REMARKS

Amendments to the Drawings

ANNOTATED MARKED-UP DRAWINGS

Fig. 1a

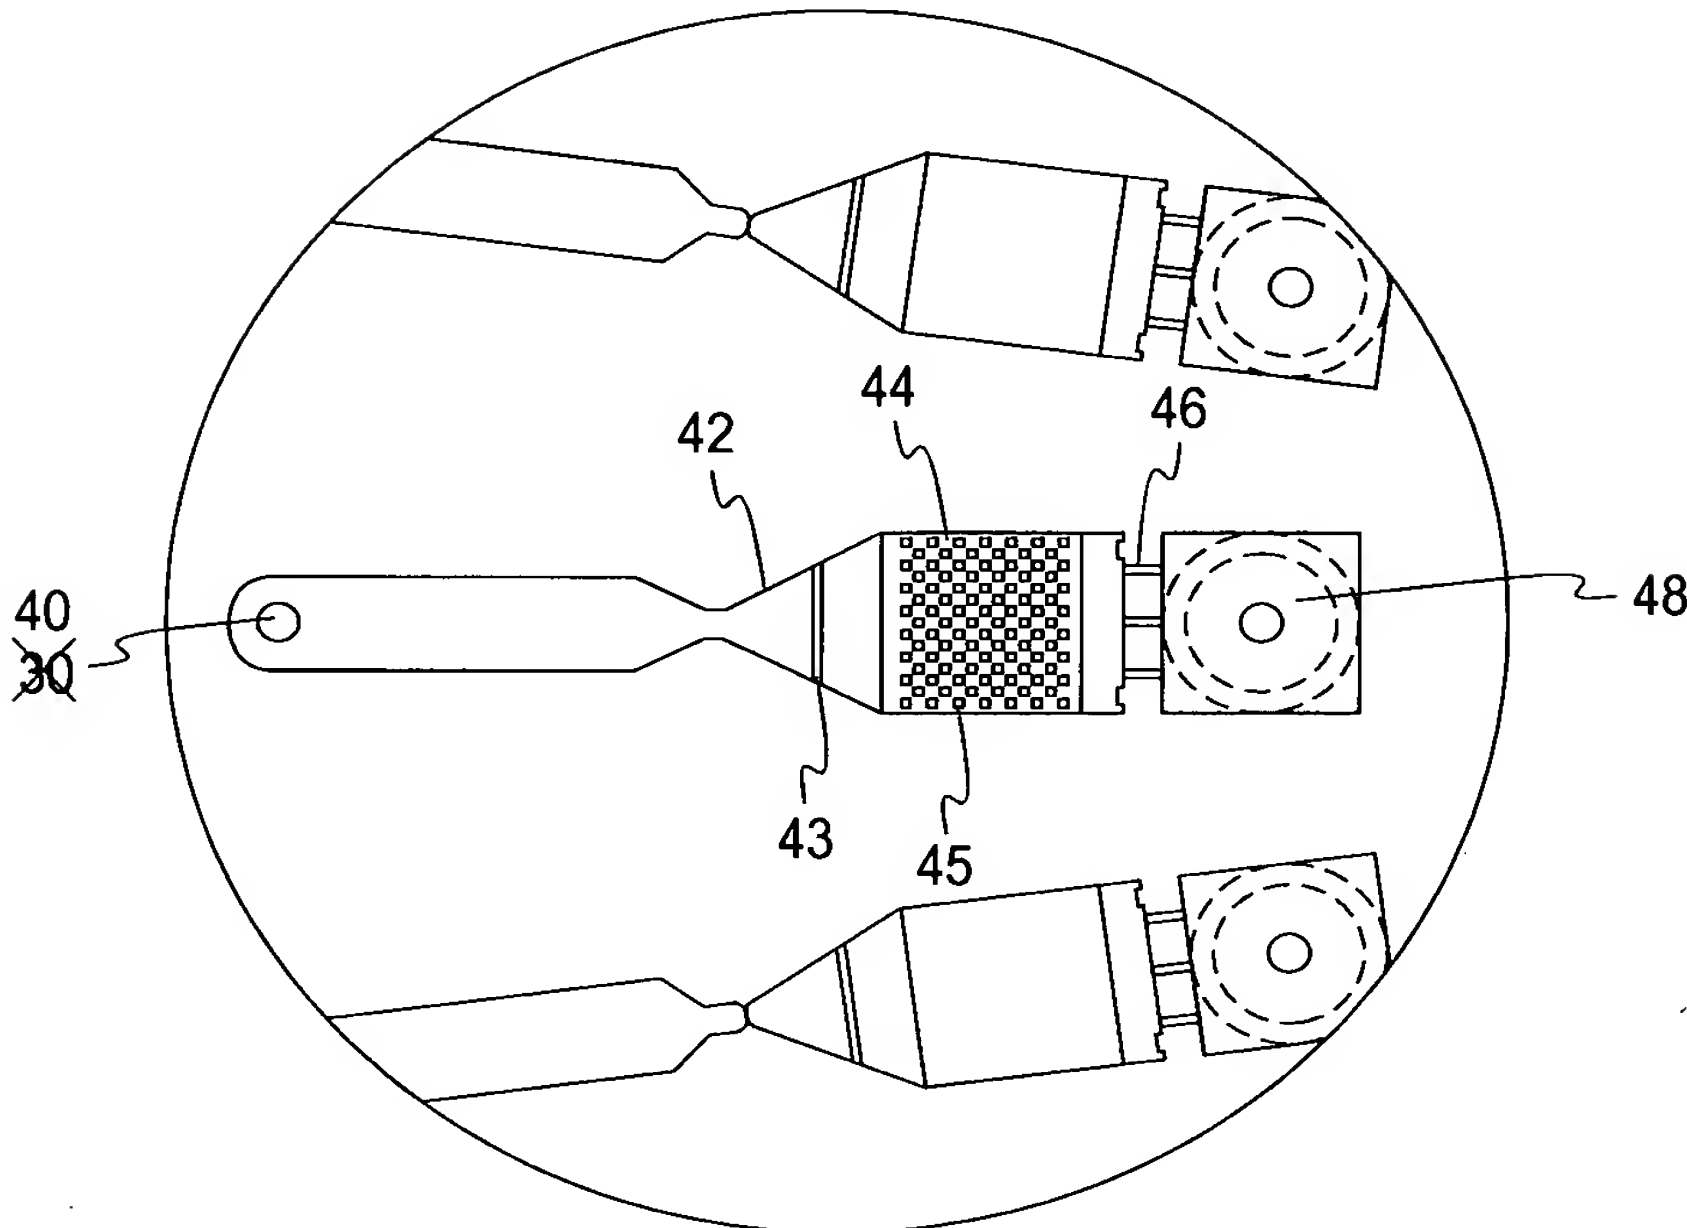
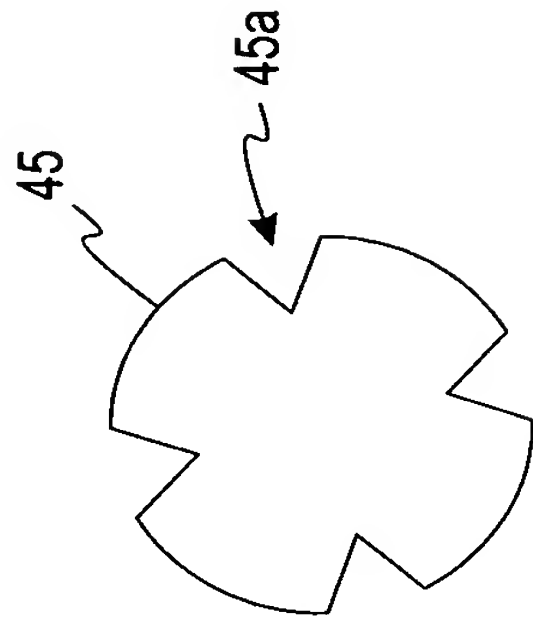
The drawings have been objected to as lacking certain features of the invention. In response, revisions have been made to Figures 1 and 5, as shown in the enclosed amended sheets. The original Fig. 1 includes a bottom view of the inlet port, passageway, inlet chamber and vent, as shown in a vertical sectional view in Fig. 2. The center portion of Fig. 1, now Fig. 1a; has been enlarged in new Fig. 1b and one of the array of posts is shown in Fig. 1c. In Fig. 5 the passageway between 10 and 12 is shown as dotted, since it is below the top of the microfluidic chip being illustrated. The specification has been amended for consistency with amended drawings.

Please replace Fig. 1 with the enclosed two replacement sheets

Fig. 5

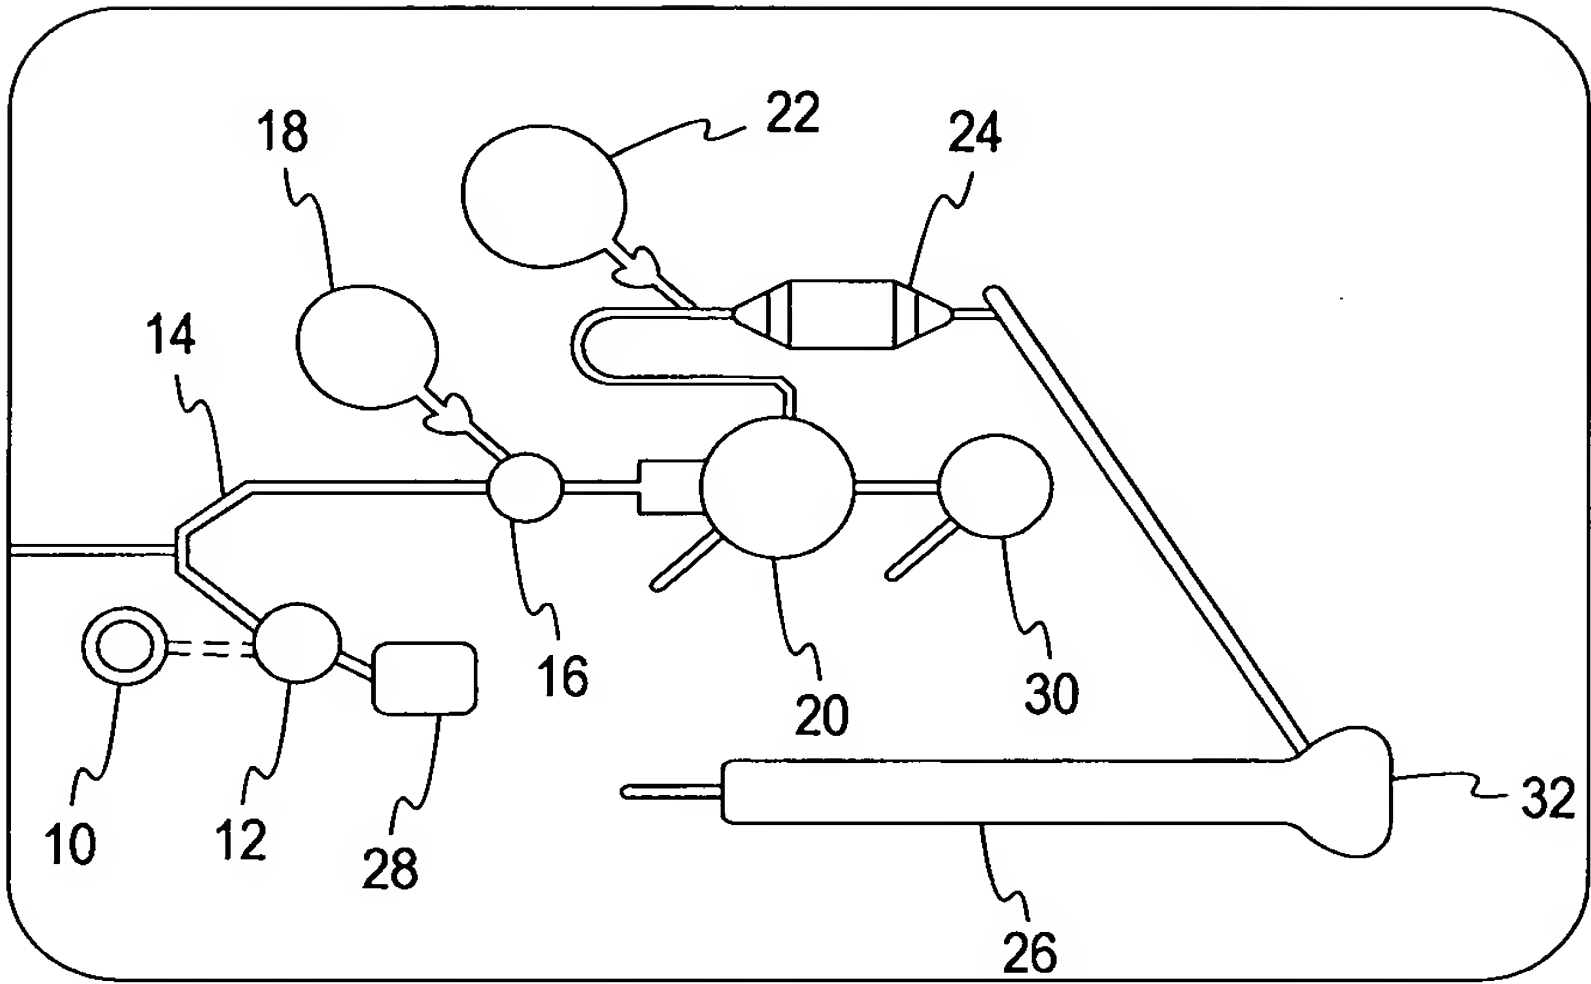
Please replace Fig. 5 with the enclosed replacement sheet.
